### 3.9.3.3 Amendments to Sections 3.6.3.1 North South Streets

### 3.9.4 Amendments to Section 3.6.2.1 Tall Buildings

FIGURE 41. View of Fire Hall No. 30 looking south; from: Villiers Street at Old Munition Street looking south

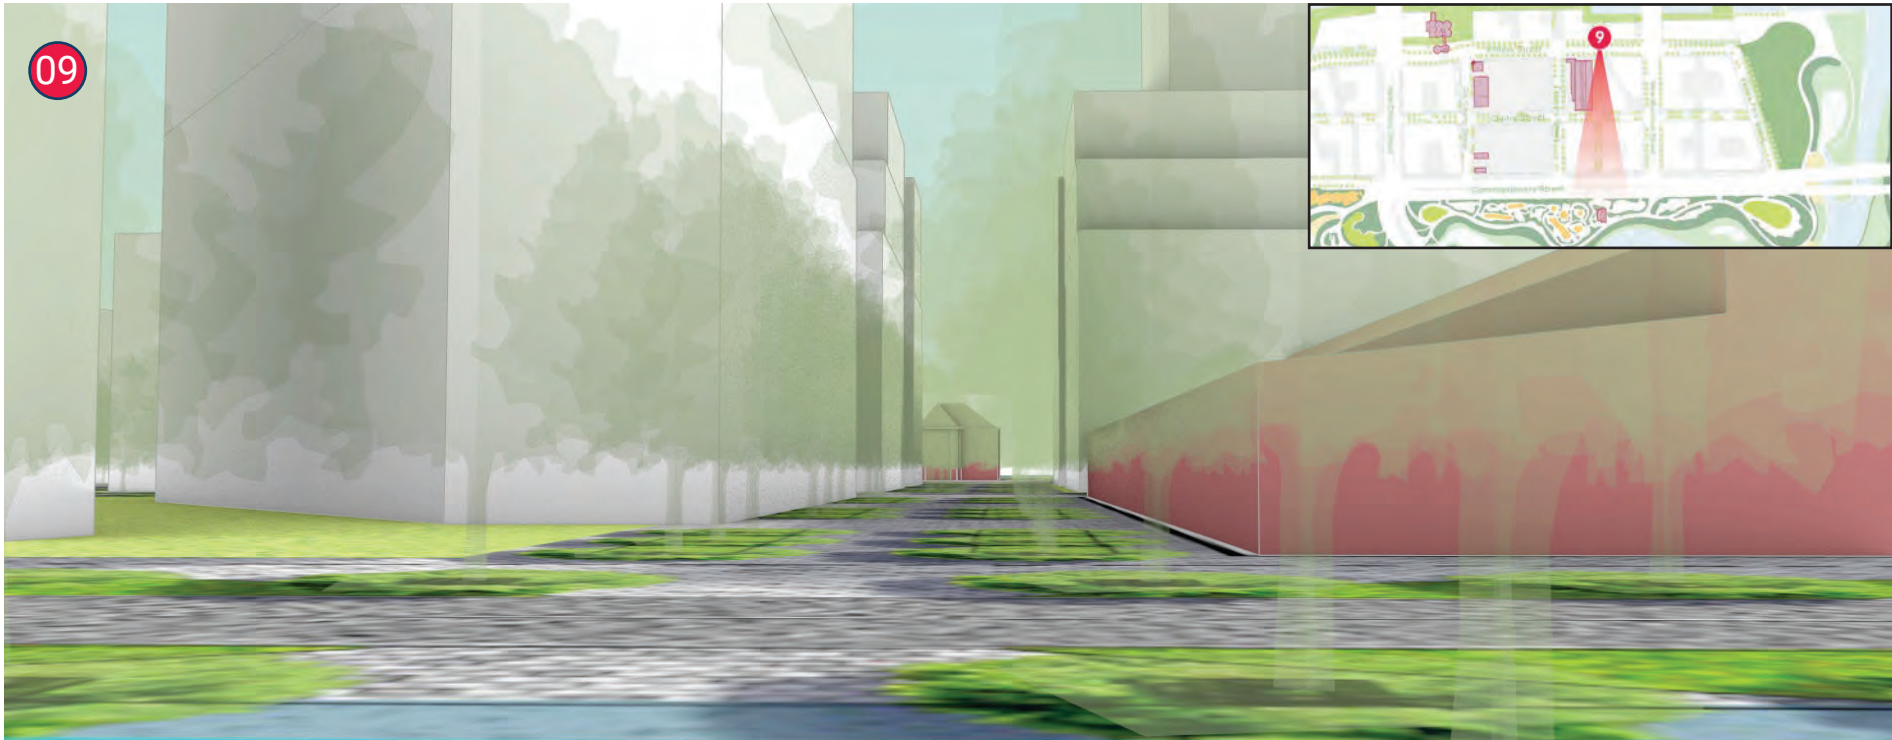
3.9.8.7 Amendments to Section 3.6.7 View 10\*: Fire Hall No. 30

2017 Precinct Plan	2024 Amendment
Fire Hall No.30 at 39 Commissioners stands at the terminus of the current alignment of Munition Street, with the Queen's City Foundry building on the west side of Munition Street. Fire Hall No. 30 will be relocated slightly south of the widened Commissioners Street. Munition Street will be shifted eastward to preserve the Toronto Harbour Commissioners buildings. A midblock connection in the street's current location will be introduced, with the Fire Hall continuing to terminate the view of the connection.	Fire Hall No. 30 stands at the terminus of the current alignment of Munition Street and has been relocated slightly south of the widened Commissioners Street. A midblock connection in the street's current location will be introduced, with the Fire Hall continuing to terminate the southward view of the connection.  *Note that the 2024 Amendment's "View 9" replaces the 2017 Precinct Plan's "View 10"
